Petition Number: 2018-142

From: Felix Obregon, PE Reviewer: Isaiah Washington

Transportation Summary

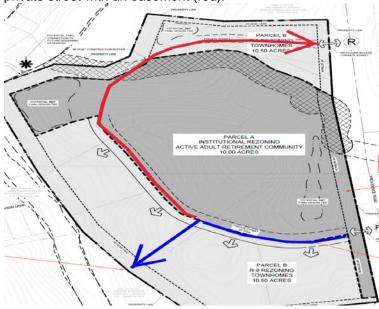
- 4. The petitioner should revise the site plan and conditional note(s) to construct a "Local Residential Wide" street from existing Hamilton Mill Road to the norther access point.

- a. The site plan and note(s) should commit to constructing and designating the southern portion as a public street (blue).
 - b. The site plan and conditional notes should commit to designating the northern portion as a private street with an easement (red).
